*City of Biddeford*

**Planning Board**

6.A. 2021.31 Final Review of a 6-Lot Cluster Subdivision for Ginger Hill Design + Build at 918 Pool Street (Tax Map 4, Lot 48) in the Coastal Residential (CR) and Rural Farm (RF) Zones.

PLANNING BOARD  
REPORT

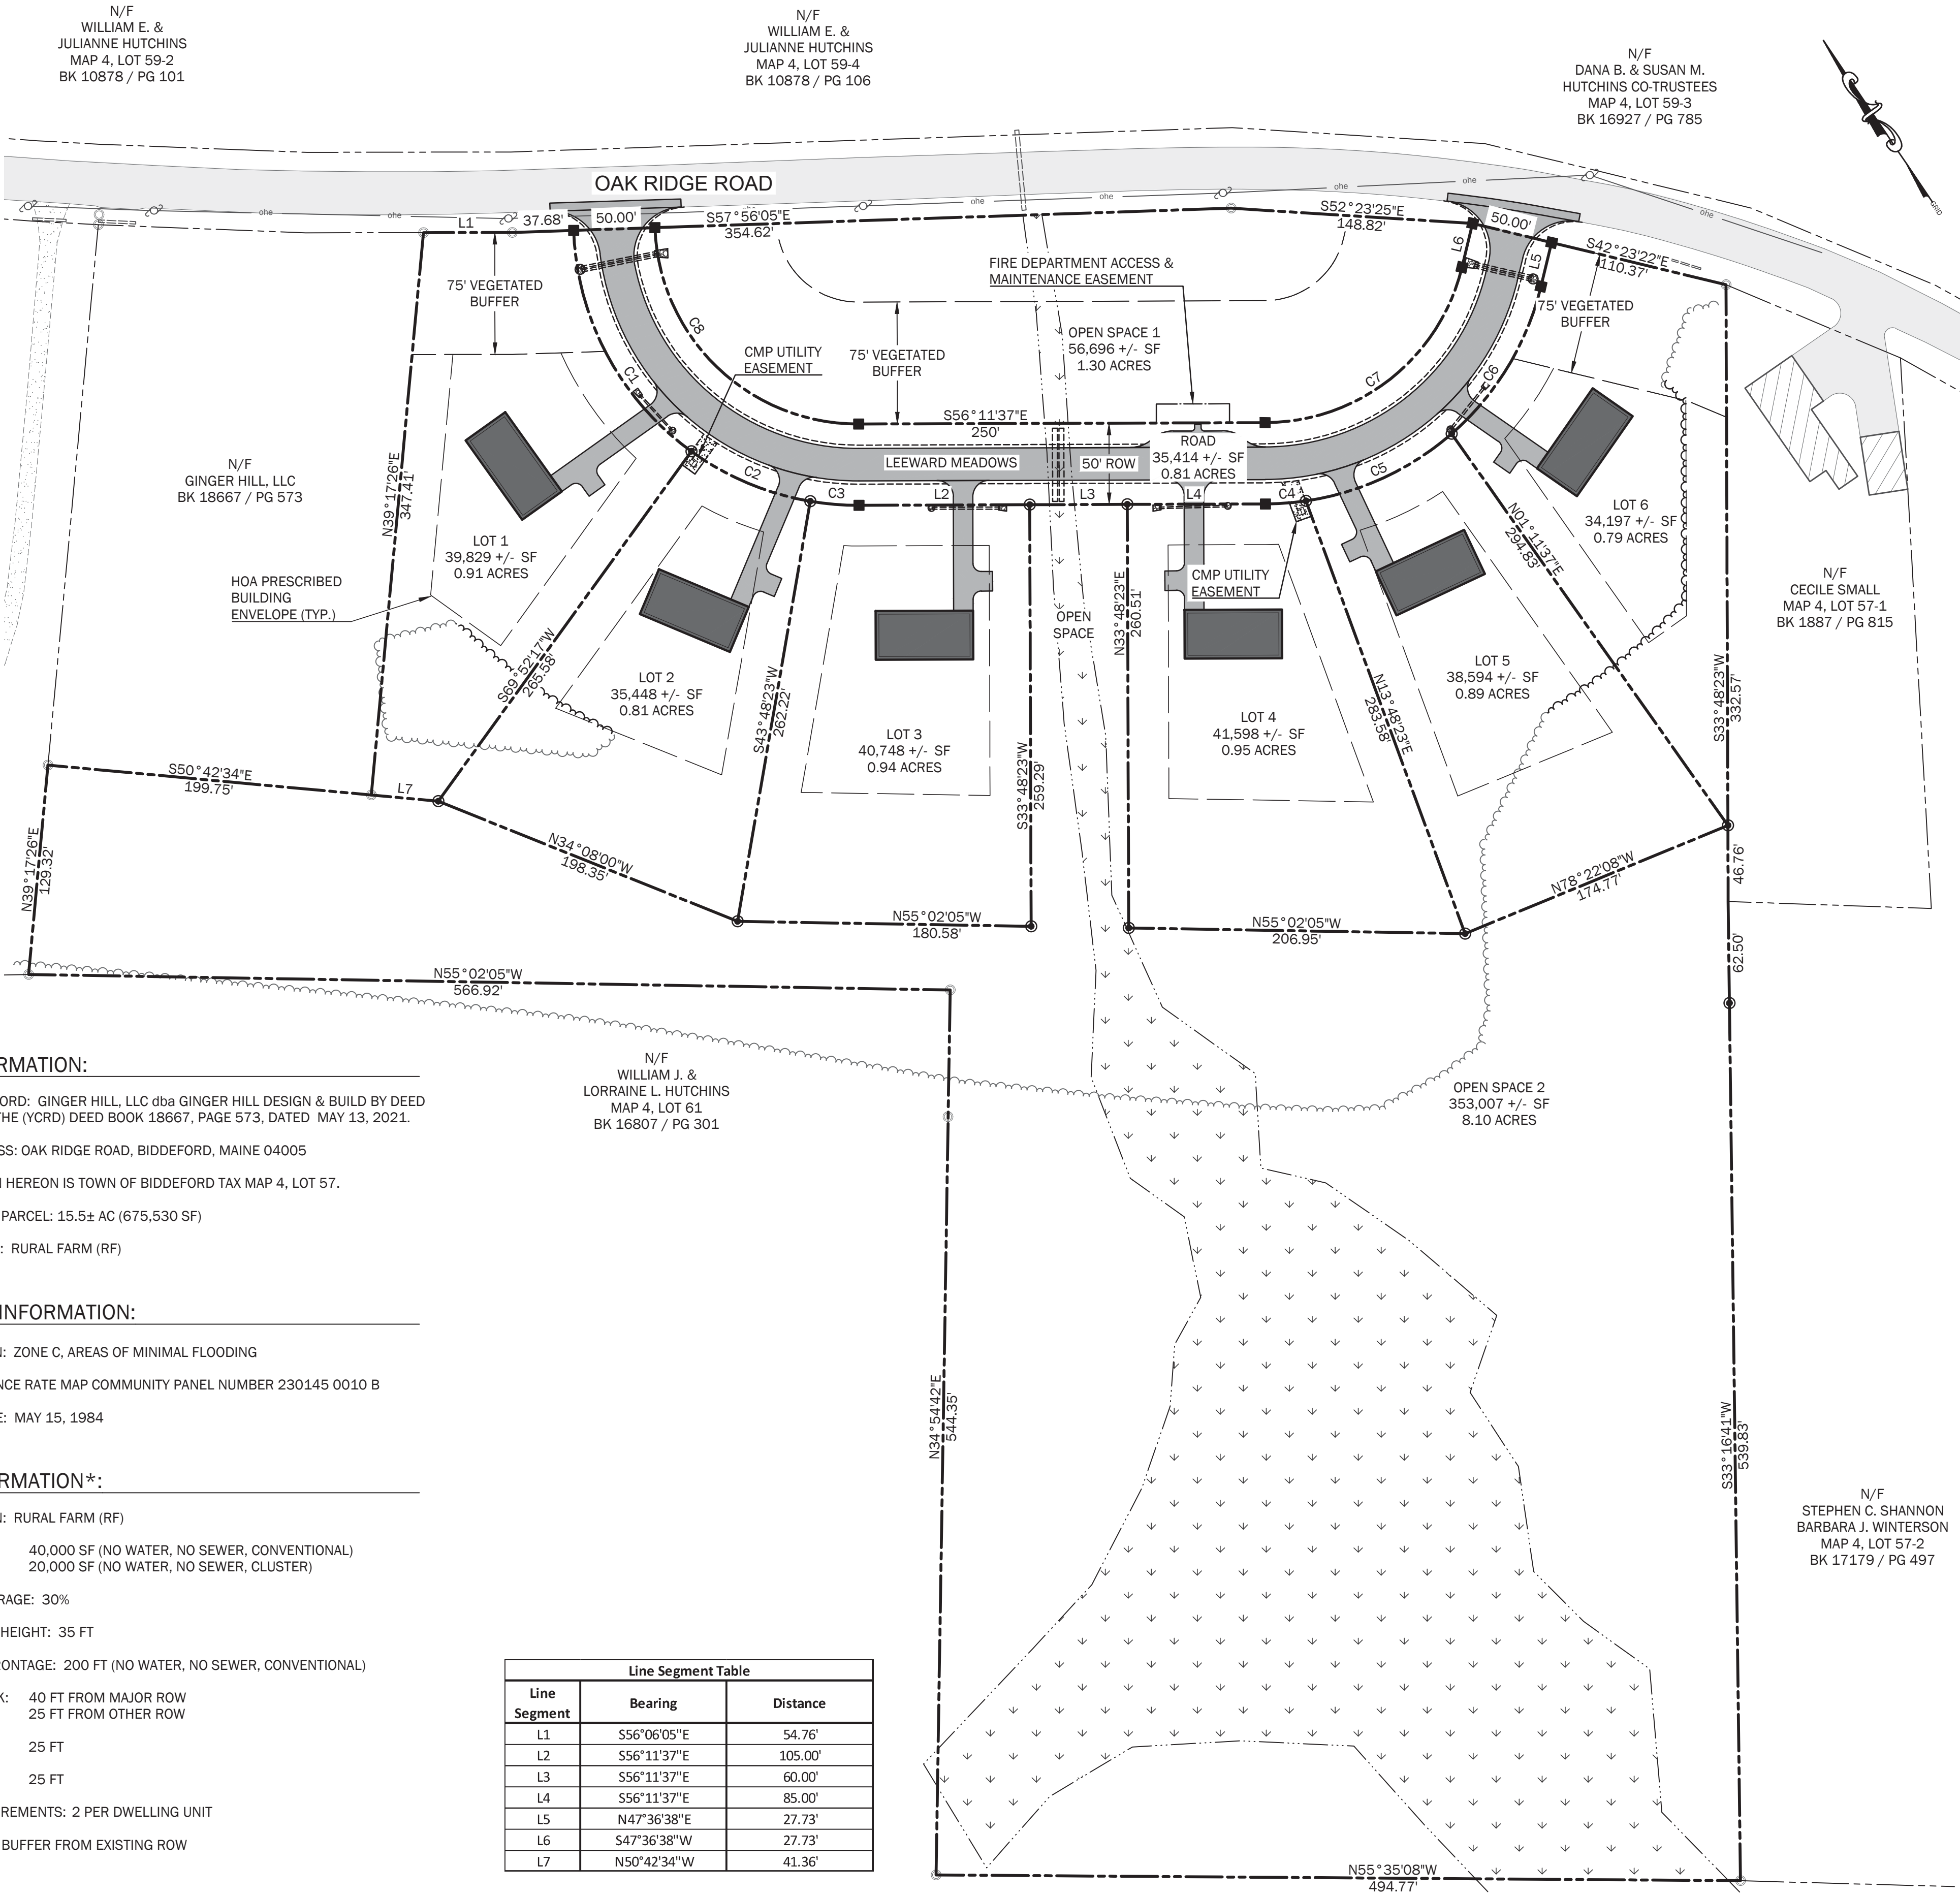
7. Comment: *Plan note 4 on Sheet S1.0 should be more specific and reference the actual declaration of covenants and restrictions and the conservation easement.*

Response: This has been addressed in the draft conservation easement and conforms to Sec. 16 and on the Subdivision Plan, Sheet S1.0

Response: Plan Sheet S1.0, note 8 has been added as requested.

Response: The 75-ft buffer was moved out of the ROW and is shown on Sheet S1.0

Response: Exhibit B of the Conservation Easement will be a reduced sized copy of Sheet S1.0. Labels identifying “Open Space 1” and “Open Space 2” have been added to Sheet S1.0 as intended by the language of the easement. There is not a third type of open space.

Response: The plan references on Sheet C1.0 reflect the sources of data shown on the plans. Note 6 has been added to Sheet S1.0 stipulating that the extents of the proposed right-of-way will be field surveyed prior to road construction as agreed upon.

Response: The notes referring to Section 51 of the City of Biddeford Code have been added to Sheet S1.0.
